FINAL RESPONSE TO COMMENTS, ERRATA & MMRP

San Ramon Valley Fire Protection District Fire Station #32

County File #LP09-2026

Prepared for
Contra Costa County

Page 5, Figure 3, has been revised.

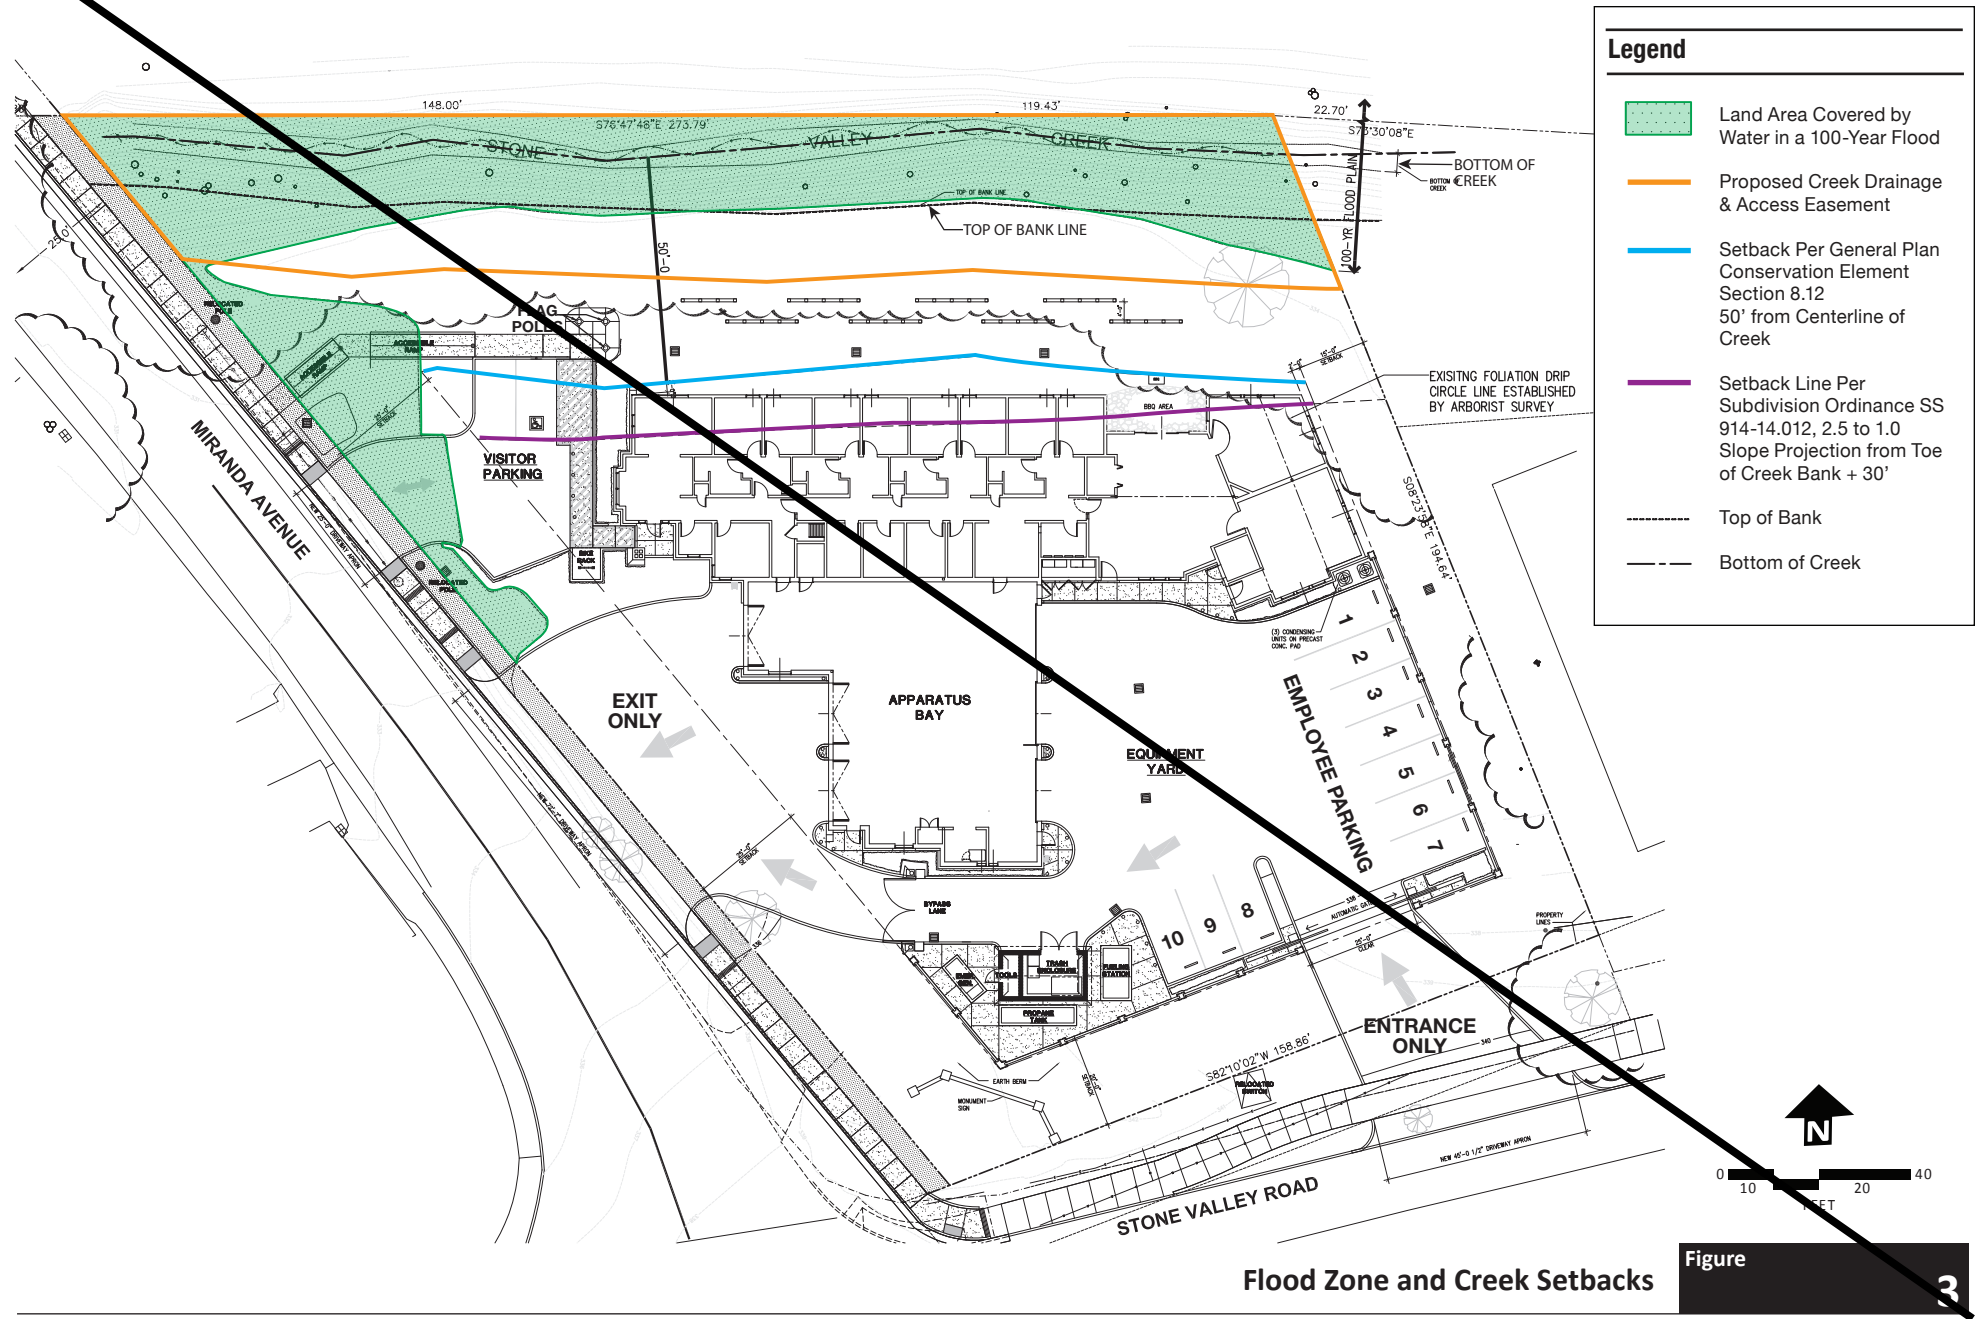
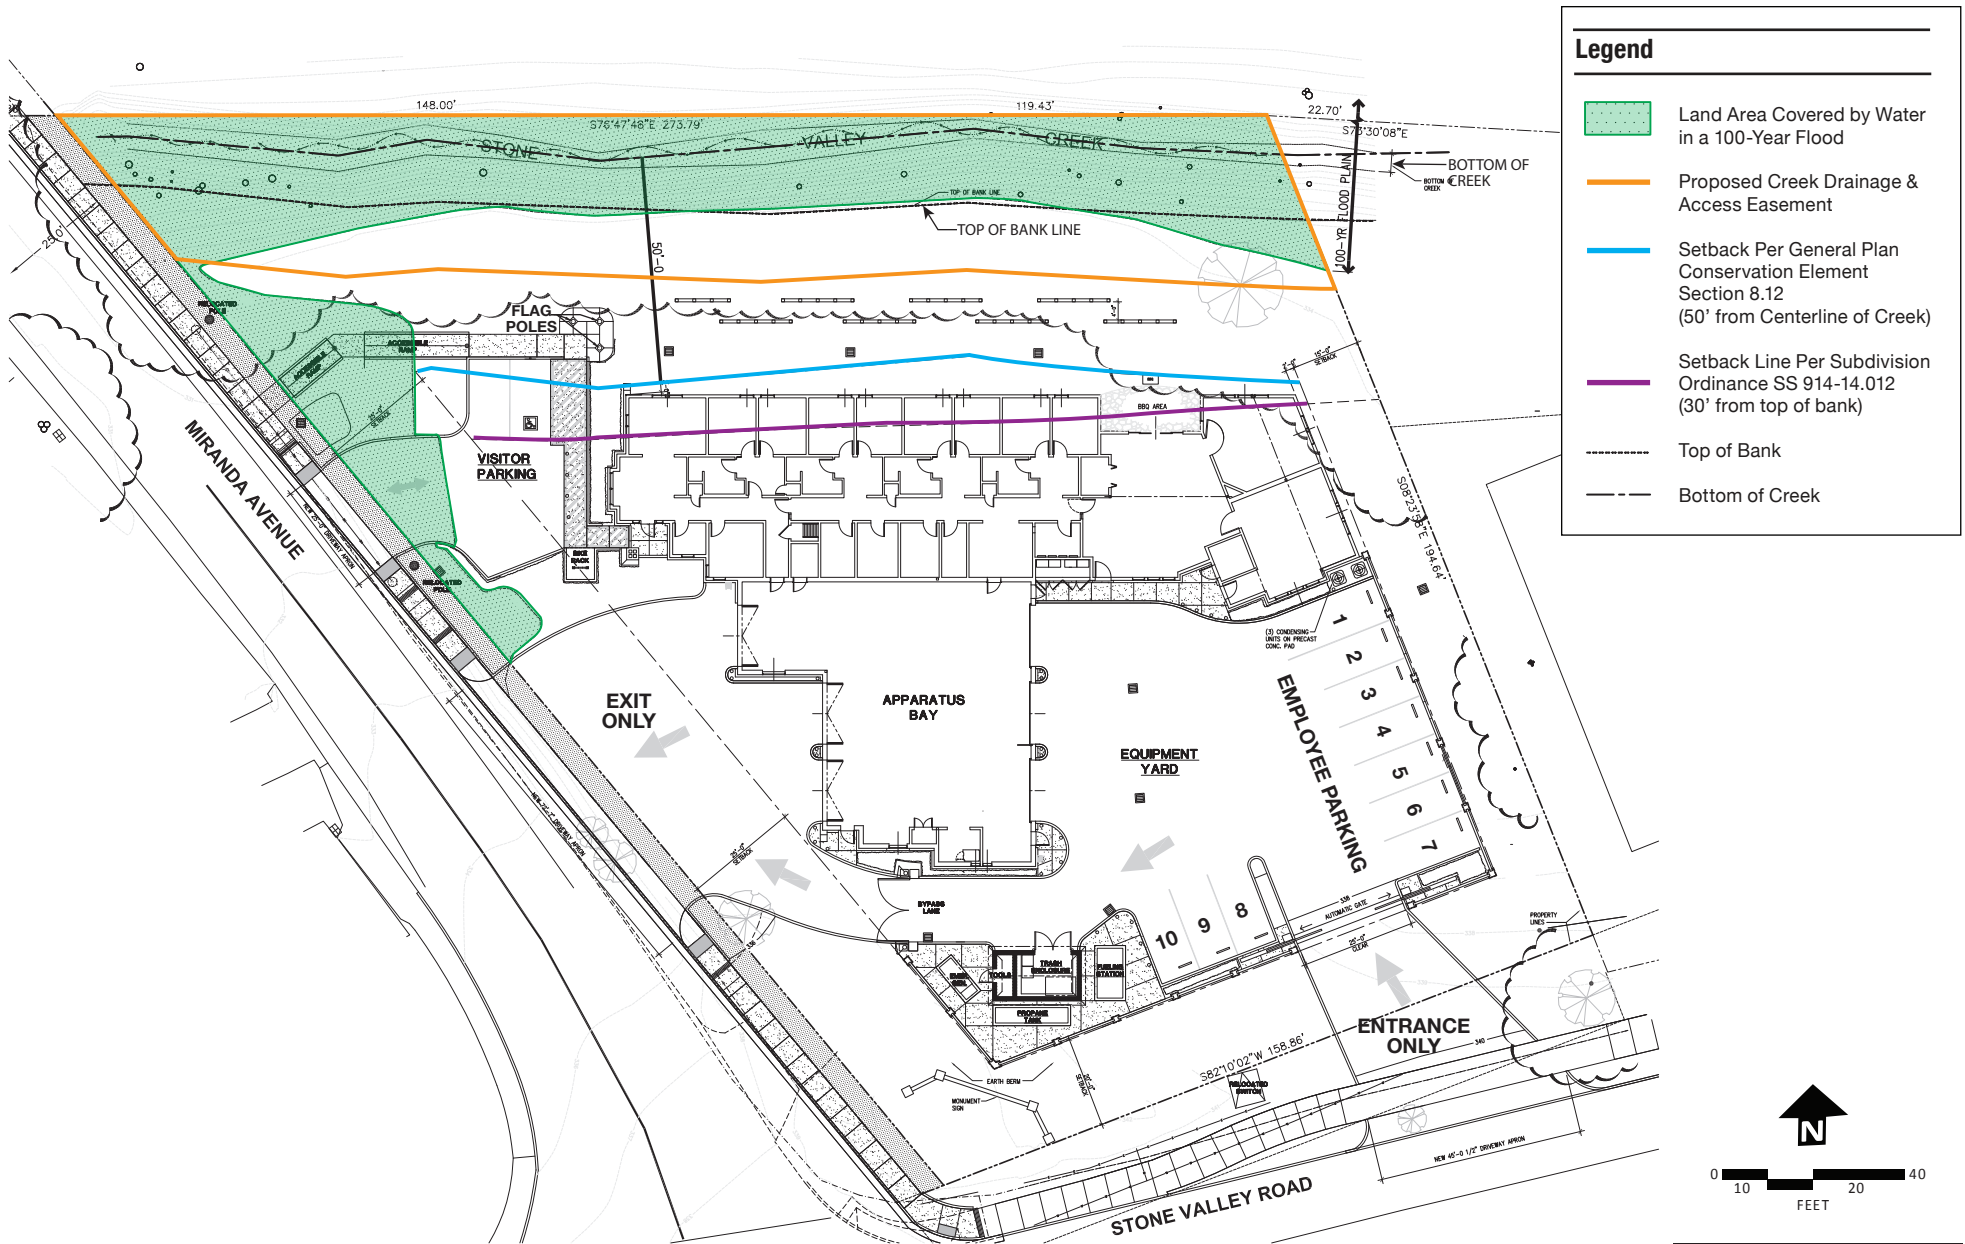
As described in the draft MND (see page 36), the dormitory would extend 11 feet into the setback area pertaining to Subdivision Ordinance 914-14.012 (see Figure 3 in the draft MND). This ordinance requires a setback of approximately 30 feet from the top of bank (as opposed to the General Plan policy that requires a 50-foot setback from the centerline of the creek). The project is requesting an exception to the setback requirement set forth in Subdivision Ordinance 914-14.012.

Then, on page 44, about half-way down the page under b) it says: "As described in the Project Description and in Figure 3, the proposed building is set back at least 50 feet from the centerline of the creek".

conforms to the 50-foot setback from centerline of the creek required by the General Plan policy 8.12). **Figure 3** shows the required setbacks from the creek and also shows the 100-year flood zone.
